HISTORIC AND DESIGN REVIEW COMMISSION

March 01, 2017

HDRC CASE NO: 2017-025
ADDRESS: 2018 AVENUE B
LEGAL DESCRIPTION: NCB 6294 (WITTIG OFFICE FURNITURE), LOT 45
ZONING: RIO-1
CITY COUNCIL DIST.: 1
APPLICANT: Jacob Wittig
OWNER: HCIST, LP
TYPE OF WORK: Exterior modifications, window restoration and installation of a new ADA entry
REQUEST:

PARTIAL WEST ELEVATION

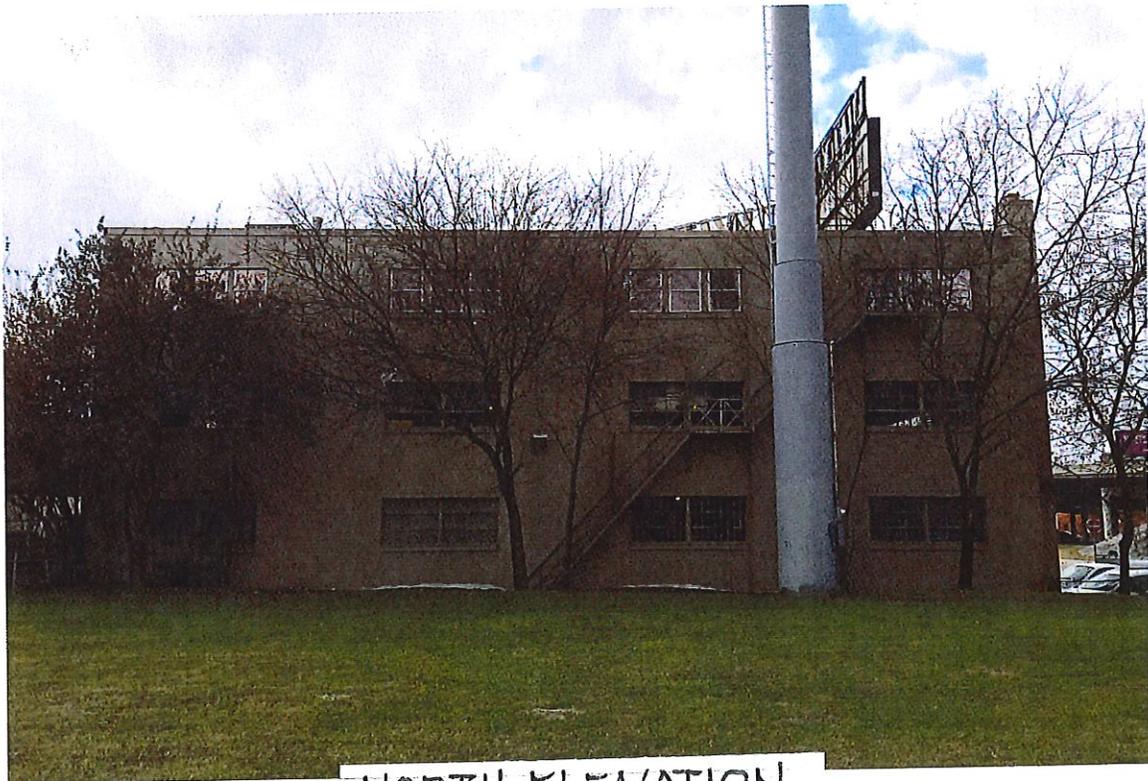
remove the existing loading docks and install a new storefront system. The applicant has proposed to maintain the existing façade openings and infill them with aluminum storefront systems. Staff finds the retention of the existing openings appropriate. The applicant should provide staff with specifics of the storefront system when returning for final approval.

- c. CONCRETE PORCH – Also on the west façade, the applicant has proposed to construct a board form concrete wall and entrance steps. Staff finds this installation appropriate and in keeping with the UDC Section 35-674. This proposed entrance addition can be distinguished from the structure’s original footprint and form.

- d. CANOPY RESTORATION – The west façade currently features an entrance canopy that appears to be original to the structure. The applicant has proposed to restore this canopy and install a standing seam metal roof to match the roofing material currently on the canopy. Staff finds this appropriate and consistent with the UDC Section 35-676.

2.10.17
SHEET TITLE:
Elevator Details
SHEET:

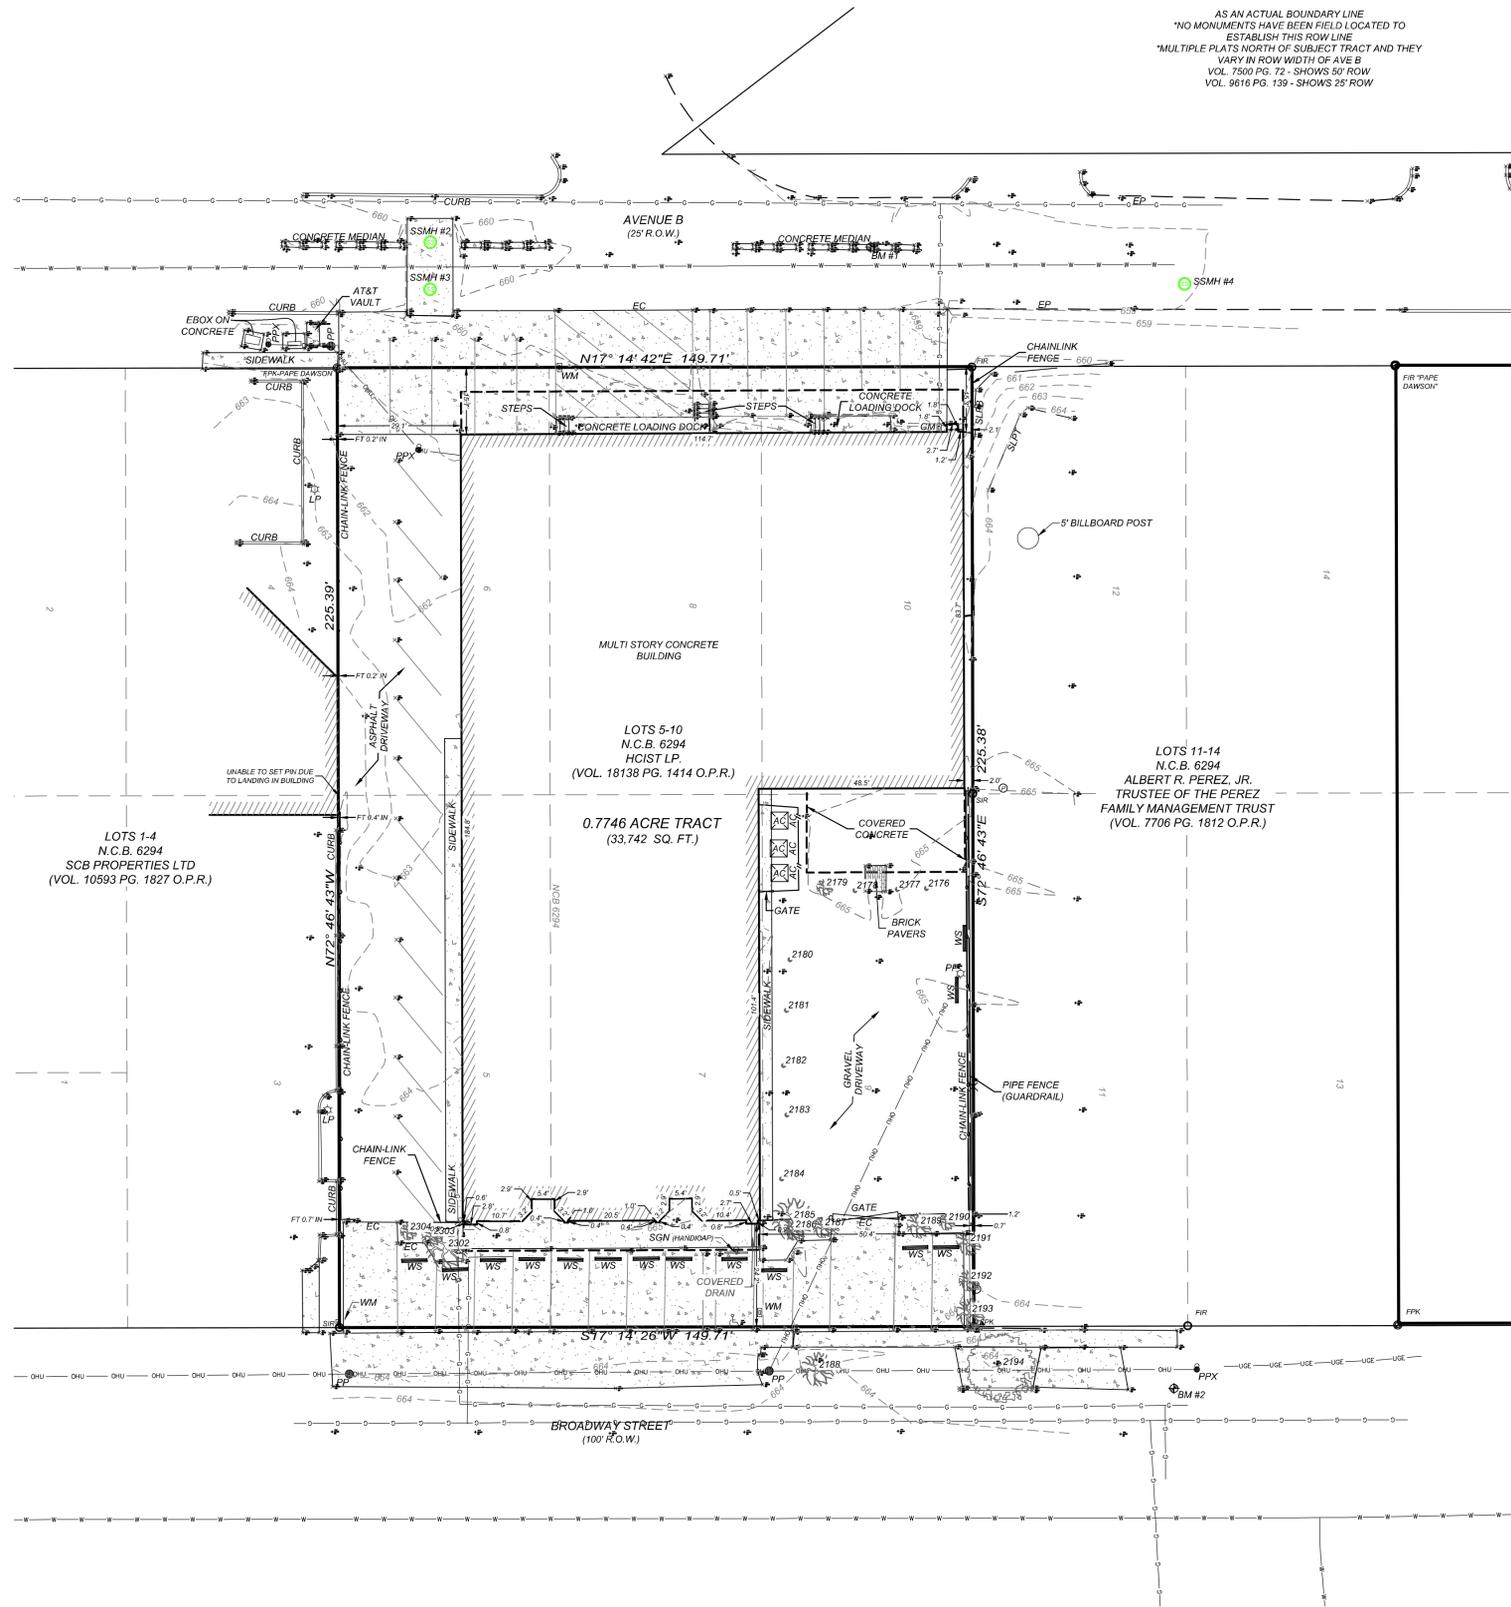
The 25-inch extension will be made of the same cement block that constitutes the existing shaft (see attached spec sheet from engineer). The overall dimensions (6 ft by 8 ft) of the penetration will not change. The extension is adjacent to a one-foot high parapet wall facing south. Only about 19 inches or less of the extended shaft penetration will be visible from a small portion of Avenue B. The extension will be painted the same color as the parapet wall so that the extension blends in with the parapet wall. To further beautify the property, we will also soon be removing a 70 ft long commercial sign along the south facing parapet wall of the building next to the elevator shaft extension. We will also be painting the exterior walls of the building in a paint scheme that is currently being reviewed by the HDRC.
